Alert Service Bulletin No. 048 Rev. 3

**Turbocharger TA0411
P/N 410188-0019 Turbine Wheel Replacement**

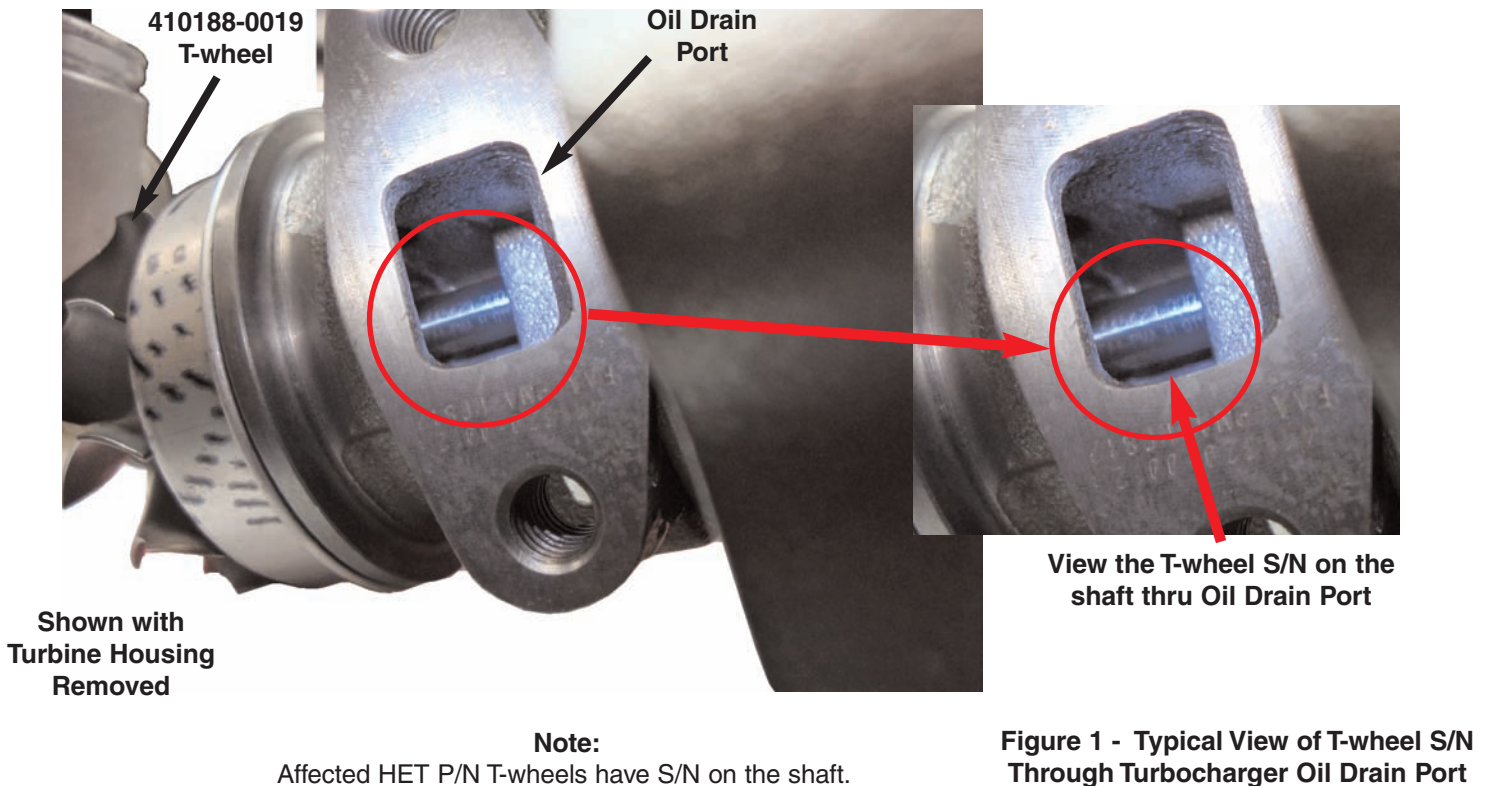
- (b) If the serial number **is listed** in Table 2, continue with Corrective Action 3.B(1).
 - (c) If the turbocharger was overhauled or repaired between August 29, 2012 and November 16, 2012 and the HET P/N 410188-0019 T-wheel was replaced, then determine if the serial number etched on the T-wheel shaft is affected. This may be done by removing the oil drain fitting and with adequate lighting, observing the shaft. (see Fig. 1).

- (i) If an affected serial number is found, continue with Corrective Action 3.B(1).
 - (ii) If an affected serial number **is not** found, reconnect the oil drain fitting per applicable aircraft and/or engine manufacturer’s maintenance manuals or service instructions. Proceed to “Return to Service” 3.C.(3).
